Product /Process Change Notification

Effective date: Mar 1st, 2017

Lite-On would like to unify packaging specification for single color 0603 package of SMD Chip LED, including C191/C193/C194/C198/C190/C19A/C181/C1932 series listed as below Table 1 below. Packaging quantity per reel, quantity per inner box, dimensions of inner box and sealed bag will be impacted.

2. Dimension of inner box & carton

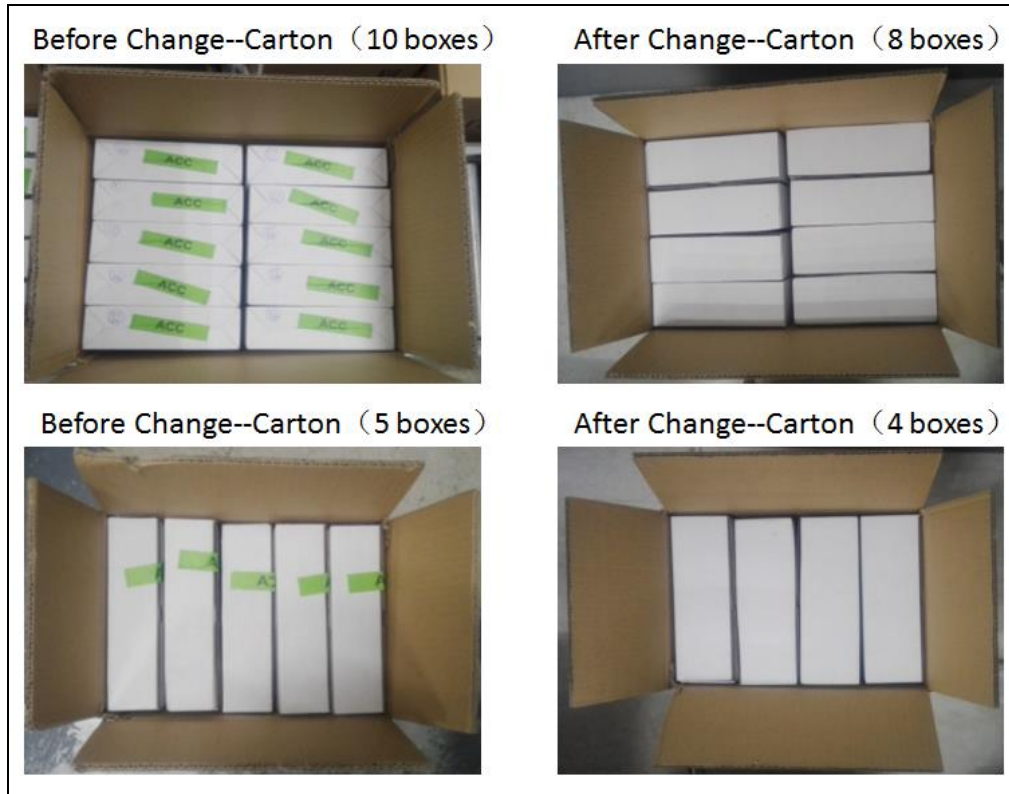
Before change				After change			
Unit : mm	Length	Width	Height		Length	Width	Height
Inner Box (3 bags)	230	200	55	Inner Box (5 bags)	247	235	70
Carton (10 boxes)	425	300	260	Carton (8 boxes)	485	305	260
Carton (5 boxes)	290	215	260	Carton (4 boxes)	305	248	260

Before change
-Inner Box (3 bags)

After change
-Inner Box (5 bags)

3. Dimension of sealed bag

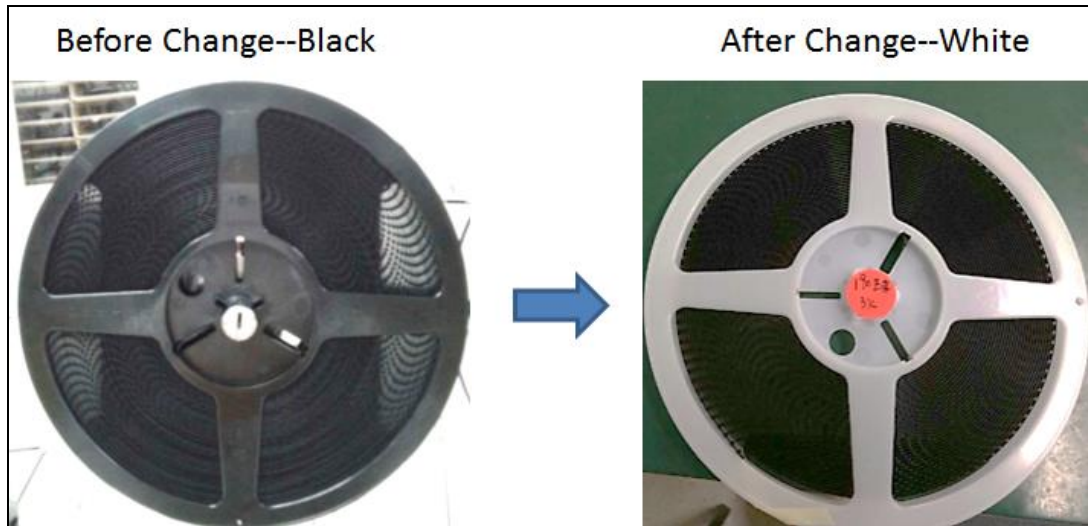
Before Change

Length: 260 +/-2mm
Width: 230 +/-2mm

After Change

Length : 240 +/- 2mm
Width : 230 +/- 2 mm
